**CITY OF AUSTIN
Board of Adjustment
Decision Sheet**

CASE NUMBER: C15-2017-0047

ADDRESS: 3602 & 3604 RIVERCREST DR

VARIANCE REQUESTED: The applicant has requested variance(s) from Section 25-2-1176 (Site Development Regulations for Docks, Marinas, and Other Lakefront Uses) (A) (1) to increase the distance a dock may extend from the shoreline from 30 feet (required/permitted) to 60 feet (requested) in order to construct a new dock in an "LA", Lake Austin zoning district.

3602 & 3604 Rivercrest Drive
CUT/FILL XSECS
& CALCULATIONS

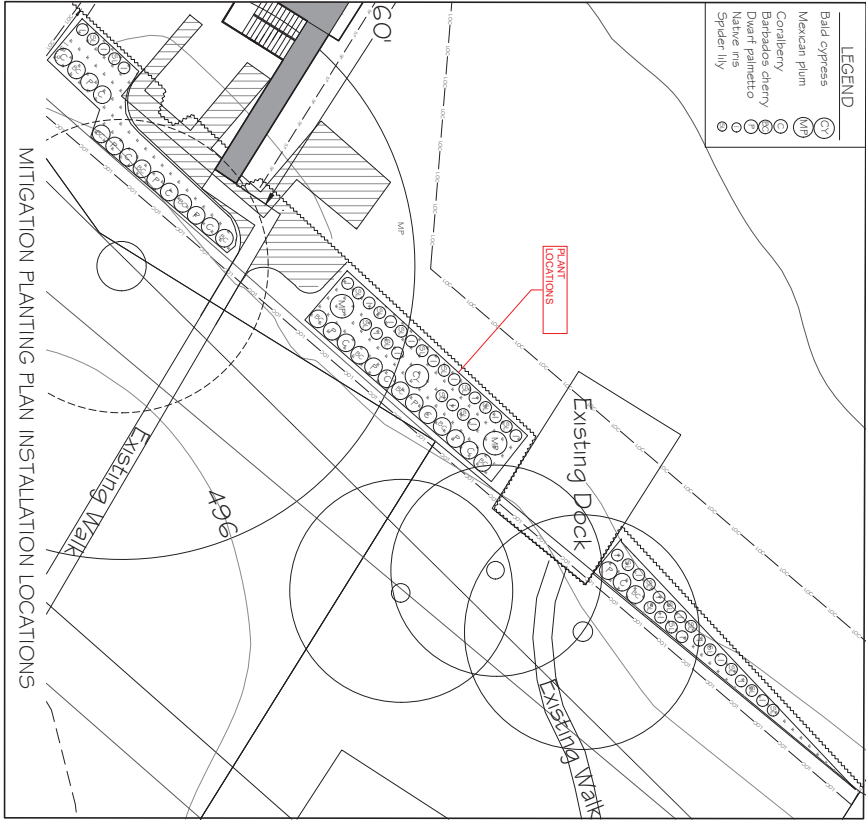
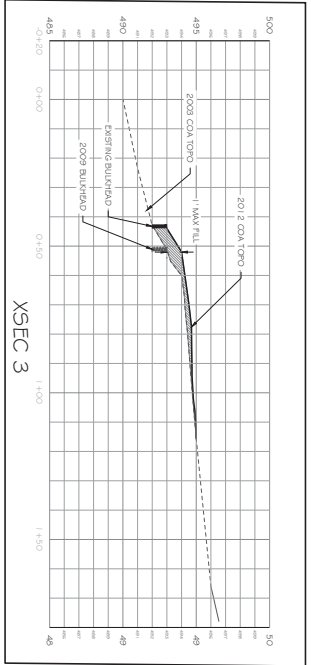
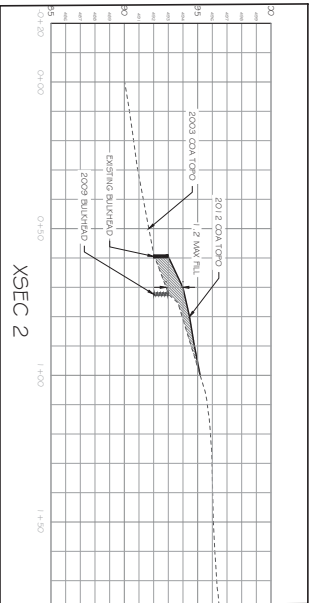
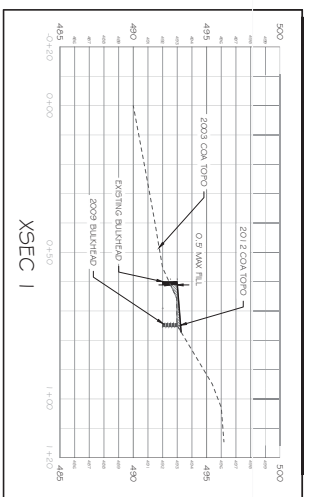
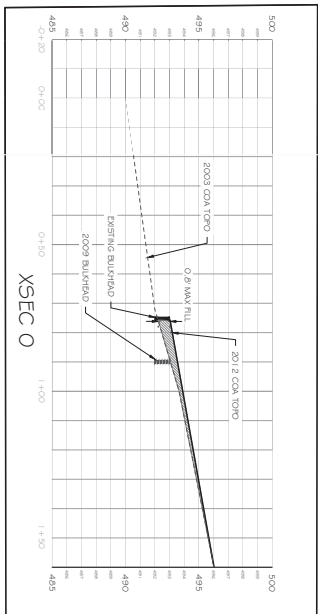
WB 3 Update 0 Provide accurate bathymetric profile information demonstrating how the 20 cubic yard dredging estimate was calculated.

Update 1: Show the dredging profile on the architectural elevation. **SEE SHEET 2**
